<b>CITY OF WESTMINSTER</b>			
<b>PLANNING APPLICATIONS SUB COMMITTEE</b>	<b>Date</b> 21 February 2023	<b>Classification</b> For General Release	
<b>Report of</b> Director of Town Planning & Building Control		<b>Ward(s) involved</b> Bayswater	
<b>Subject of Report</b>	<b>The Colonnades, 34 Porchester Square, London, W2 6AP</b>		
<b>Proposal</b>	Details of plan indicating a clear and unobstructed route for pedestrians of The Colonnades to access the residential waste and recyclable storage within the service yard of The Colonnades pursuant to condition 32 of planning permission dated 06 October 2022 (RN: 21/04074/FULL)		
<b>Agent</b>	Hanna Corney		
<b>On behalf of</b>	Hanna Corney		
<b>Registered Number</b>	22/07920/ADFULL	<b>Date amended/ completed</b>	24 November 2022
<b>Date Application Received</b>	22 November 2022		
<b>Historic Building Grade</b>	Unlisted		
<b>Conservation Area</b>	Bayswater		
<b>Neighbourhood Plan</b>	Not applicable

**Proposal:** Details of plan indicating a clear and unobstructed route for pedestrians of The Colonnades to access the residential waste and recyclable storage within the service yard of The Colonnades pursuant to condition 32 of planning permissi

Proposed Plan

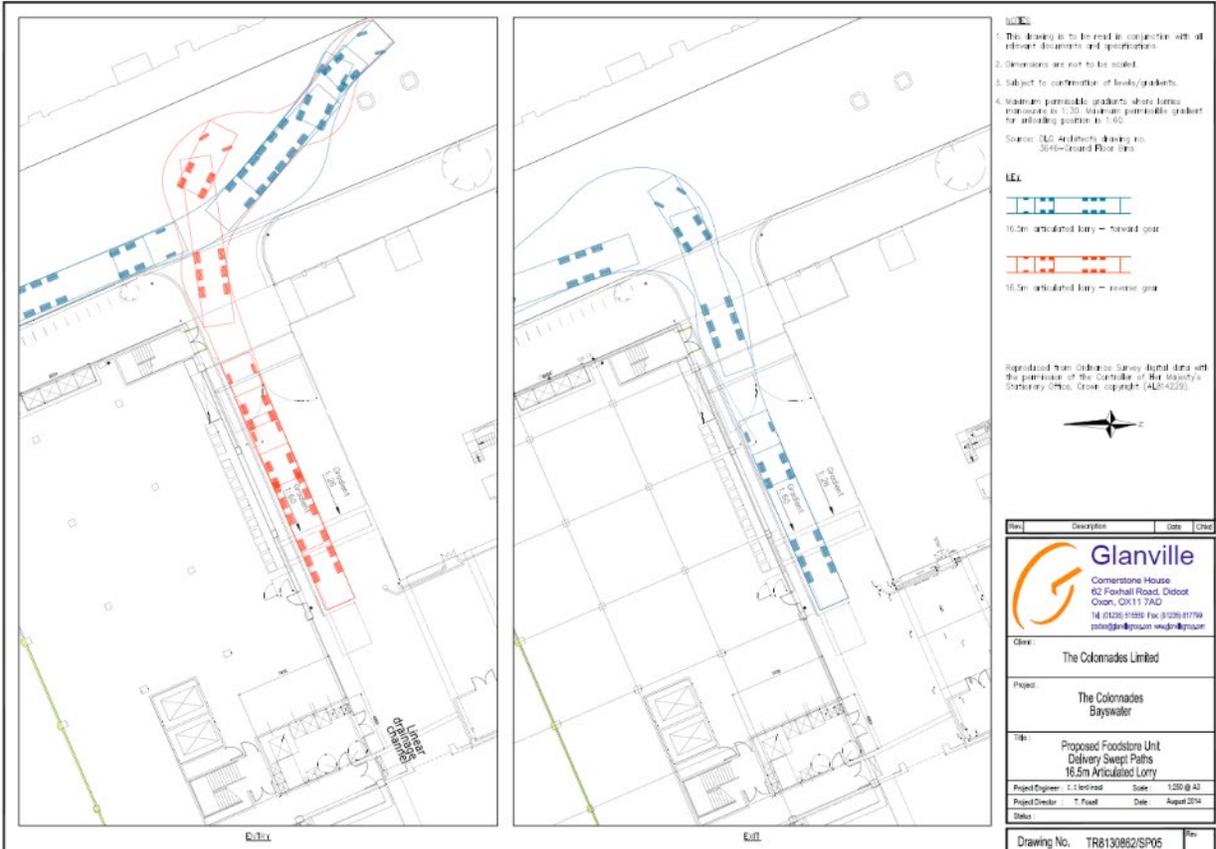
Councillor Sullivan also comments that the route will not be sufficiently unobstructed through the use of only yellow paint; and that an assessment of actual vehicle movements should be made taking into consideration this designated area. Physical segregation would achieve an unobstructed and safe route. Comment is further made that there are no details as to how 'accessible' the route is in terms of its width; level access; whether this is sufficiently lit and whether this is suitable for those with visual impairments.

Originally forwarded an objector's email. This was followed up by a further objection on the grounds that there should be a safer enclosed route for the residents of the Colonnades to access the refuse and recycling big bins in covered area to rear of service yard for the Colonnades commercial units. SEBRA are not convinced that the open yellow crossed hatched walkway will give the necessary protection to the residents going to and from the bins.

- The plan goes against the Planning Inspectorates decision of December 2021
- The plan only shows a route inside the service yard and no detail on access routes for residents to that; and is therefore the plan is incomplete
- The new route will have to be accessed by residents using public footways and require access to multiple locked gates – this means that residents may as well

- The dimensions of the gate are not given
- The marking of paint on the floor is not sufficient and does not protect residents safely
- Does the route allow able bodied and wheelchair users to access their bins
- Residents should not have to wear high visibility outerwear when using the route
- The route as shown would impact the turning circle and swept path analysis as submitted in the original planning application
- Why has this application been submitted in this manner and not as part of the application 21/040741/FULL?

One objection is on the grounds that the plan proposes a route solely within the service yard and does not show where this comes from with The Colonnades itself, and therefore the plan does not comply with the condition.

The objectors consider the new route to be unacceptable as this will have to be accessed by residents using public footways and require access to multiple locked gates meaning that residents may use the on street public waste and recycling facilities, which again is contrary to the previous Planning Inspector's advice.

Objections have been made on the grounds that the marking of paint on the floor is not sufficient and does not protect residents safely from vehicles in the service yard, some noting that the route would in fact be hindered by the turning circle and swept path analysis as submitted and approved in application 21/04074/FULL.

A further objection raises the issue accessibility to all and asks does the route allow able bodied and wheelchair users to access their bins. If there are any wheelchair users wanting to use the refuse and recycling in the service yard, then if access can be gained to the communal areas of The Colonnades, where they live, access can be gained to the bins. As a point to note however, at this time there does not appear to be level access to the 100 or 200 block of The Colonnades from Porchester Square. The gate opening is 1.2m wide and this is sufficient for a wheel chair user, which requires 0.9m. In terms of those who are visually impaired, the proposed route results in no worse a situation than if the route to the refuse and recycling area was proposed through the lift in the building into the service yard as vehicles are still allowed to use the undercroft area for servicing and turning.

The plan submitted shows that a new resident gate, 1.2m wide\* is to be incorporated into the existing full height black gates which leads from the service yard to the communal walkway of The Colonnades, known as Porchester Mews. The plan is annotated to say that the gate will have a pin code. The gate leads to a new yellow painted route from Porchester Mews to the existing refuse area, running parallel with the existing walls of the substation.

\*The gate measures 1.2m when scaled from the drawing. One objection was received on the ground of lack of dimensions on the plan. A drawing does not have to have the written dimensions on it so long as the drawings are to scale.

Given the history of the site, the numerous planning applications submitted and that it is assumed that residents who live in the Colonnades are acquainted with the service yard, officers consider that the plan is clear in where it is proposing a route from. It is annotated to show Porchester Mews and the key makes it explicitly clear that a new gate is proposed from within the gated and communal walkway. Officers consider it appropriate to accept this plan as a valid submission in order to discharge this planning condition.

The proposed route does mean that users of the refuse and recycling facilities will have to exit the building either from the entrance/ exit in the lower ground floor of Block 200 (for those residents in Blocks 100, 200 and 300) or the front door to the houses and the mews and navigate one or two locked gates, depending on where they reside in the building. These are not within public footways as suggested but are communal pathways, gated with The Colonnades, solely for the use by The Colonnades residents. Access via gates is not considered objectionable and these security measures are a common occurrence in gated developments and modern developments. It must here be remembered that refuse and recycling (save for boxes/packaging) is collected frequently from each residential unit, with residents bagging their refuse and recycling in their individual refuse store outside of their flat front door between 21.00 and 07.00 and then porters collect this daily between 07.00 and 09.00, except Christmas Day and New Year's Day. The frequency in which residents will be using the refuse and recycling facilities in the undercroft of the service yard is not assumed to be significant and this proposed route is considered acceptable.

It is acknowledged that the route is marked only in paint. The applicant was asked why a barrier or intermittent bollards could be sited on outer edge of the route demarcation area. At the time of writing, no firm response had been given to this point, and it is assumed that any physical barrier on the outer edge of route demarcation could potentially reduce the servicing area and potentially impact on the swept paths of servicing vehicles. The applicant has advised that they will review their position on a barrier prior to committee and any update will therefore be provided by officers. However, at 1.2m wide for the most part the swept paths do not appear to be affected. For clarity, the applicant has been asked to overlay the proposed route over the swept path plans but at the time of writing these plans had not been received. As secured under the most recent servicing and management plan (approved under application 21/04074/FULL) a facilities manager is on site between 07.00 and 19.00 daily to ensure that all deliveries to, and refuse collection for, The Colonnade shopping arcade is undertaken within the service yard. They will also ensure the service yard is kept clear of obstructions at all times. The adherence to this part of the servicing management plan will ensure that a resident is not in harms way should a delivery be occurring when they want to access the refuse and recycling facilities. Again, it must be remembered the frequency as to use of the refuse and recycling in the service yard, given the existing refuse collection arrangement in place. Coupled with the fact that residents have the right now without any formal route to use the refuse and recycling areas in the service yard, the proposals are considered to strikes a fair balance in terms of provision of a route and safety.

As a final point, one of the objectors notes that residents should not have to wear high visibility outerwear when using the route. Whilst the residents concerns about their safety are well understood, it is considered that this painted designated route offers is appropriate and provide a clear and unobstructed route which the Condition sought to provide.

The plan is considered acceptable and shows a clear and unobstructed route for pedestrians from The Colonnades to the refuse area and therefore it is recommended to discharge this condition.
